RF Microelectronics, Second Edition

Errata

Behzad Razavi

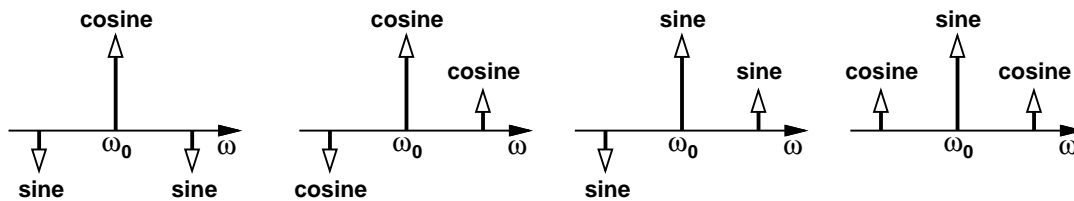
- Example 2.11, change Eq. (2.53) to $3.16 V_p$ and Eq. (2.54) to $+20$ dBm.
- On page 40, last paragraph, the noise current of a resistor should read $\overline{I_n^2} = \overline{V_n^2}/R_1^2$.
- Prob. 2.3, second line should read: consider the cascade of identical ...
- Prob. 2.5 should read $\omega_3 - \omega_2 = \omega_2 - \omega_1$.
- Fig. 3.9 should be changed as shown below:

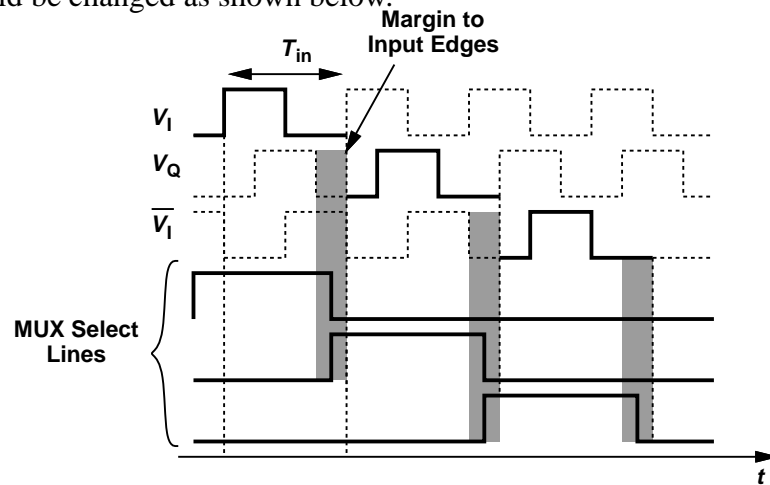
- In Eq. (8.19), change ϕ_0 to ϕ_1 .
- In the sentence above Eq. (8.43), change rad/Hz/V to rad/s/V.
- Fig. 8.84 (b) should be changed as shown on the next page.

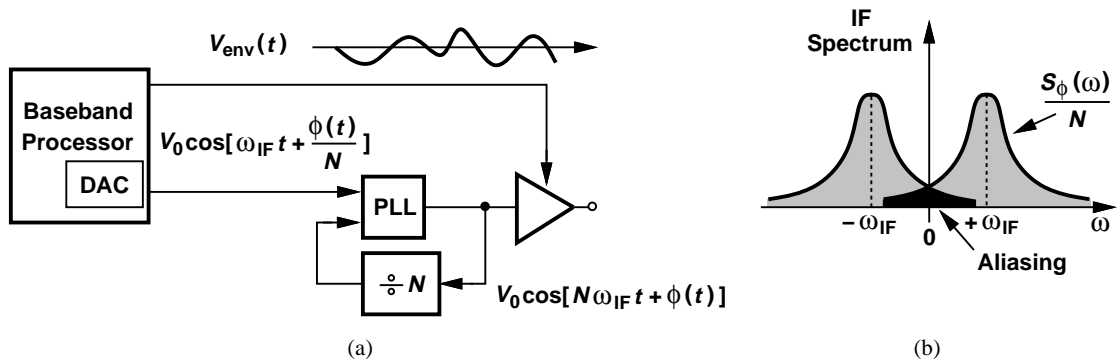
- Fig. 12.53(b) should be changed as shown below.
- Problem 12.3 should read: Prove that in Fig. 12.17, the voltage swings above and below V_{DD} are equal to V_p/π and $V_p(\pi - 1)/\pi$, respectively, where V_p denotes the peak voltage at each node. (Hint: the average value of V_X and V_Y must be equal to V_{DD} .)
- In the solution of Example 13.1, the second line should read: However, a 64QAM OFDM signal exhibits And the last sentence should read: The -82 -dBm PSK OFDM signal
